**Communication : C 51**  
**Committee of the Whole (2)**  
**June 8, 2021**  
**Item # 8**

**VAUGHAN COMPREHENSIVE ZONING BY-LAW- 2748355 CANADA INC., MOBILIO DEVELOPMENTS LTD., RP B3N HOLDINGS INC., AND RP B3S HOLDINGS INC. COMMENTS**

On behalf of our clients, IBI Group wishes to provide the following comments on the proposed Comprehensive Zoning By-law (CZBL). The intent of this letter is to highlight our main concerns and comments on the proposed CZBL.

**Figure 1. Landmark Locations from Schedule A2 of Zoning By-law 1-88**

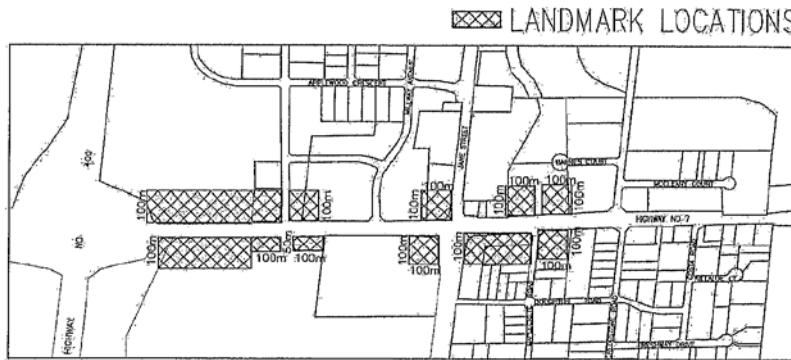
IBI Group would also like to highlight that notable provisions from Zoning By-law 1-88 are missing from the current Draft Comprehensive Zoning By-law, including the Landmark Location provision from Schedule A2 of Zoning By-law 1-88 (**Figure 1**). This provision permits unlimited height in certain locations along Highway 7 to serve as a gateway to the Highway 7 corridor. IBI Group is not supportive of the exclusion of these provisions from the Comprehensive Zoning By-law and wish to see them included in the Second Draft. Several towers have already been approved and/or constructed along Highway 7 within the Landmark Locations, setting a precedent for the built-form along this corridor. The removal of these provisions will create a disconnect between the built-form, conflicting with several of the City’s Urban Design objectives and creating great variations in height and density.

**Figure 1. Landmark Locations from Schedule A2 of Zoning By-law 1-88**

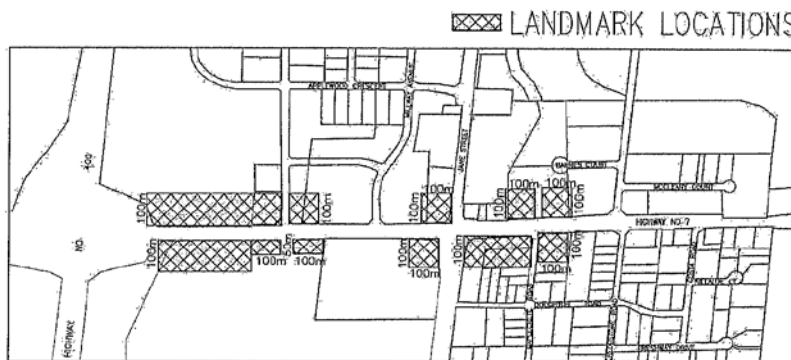
IBI Group would also like to highlight that notable provisions from Zoning By-law 1-88 are missing from the current Draft Comprehensive Zoning By-law, including the Landmark Location provision from Schedule A2 of Zoning By-law 1-88 (**Figure 1**). This provision permits unlimited height in certain locations along Highway 7 to serve as a gateway to the Highway 7 corridor. IBI Group is not supportive of the exclusion of these provisions from the Comprehensive Zoning By-law and wish to see them included in the Second Draft. Several towers have already been approved and/or constructed along Highway 7 within the Landmark Locations, setting a precedent for the built-form along this corridor. The removal of these provisions will create a disconnect between the built-form, conflicting with several of the City’s Urban Design objectives and creating great variations in height and density.

**Figure 1. Landmark Locations from Schedule A2 of Zoning By-law 1-88**

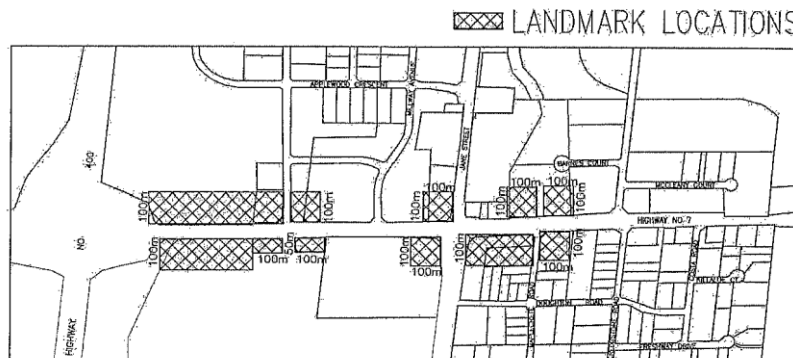
IBI Group would also like to highlight that notable provisions from Zoning By-law 1-88 are still missing from the Second Draft Comprehensive Zoning By-law, including the Landmark Location provision from Schedule A2 of Zoning By-law 1-88 (**Figure 1**). This provision permits unlimited height in certain locations along Highway 7 to serve as a gateway to the Highway 7 corridor. IBI Group is not supportive of the exclusion of these provisions from the Comprehensive Zoning By-law that essentially downzone the parcels and wish to see them included in the Final Draft. The removal of these provisions will create a downzoning that is inconsistent with provincial policy related to urban growth centres and MTSAs.
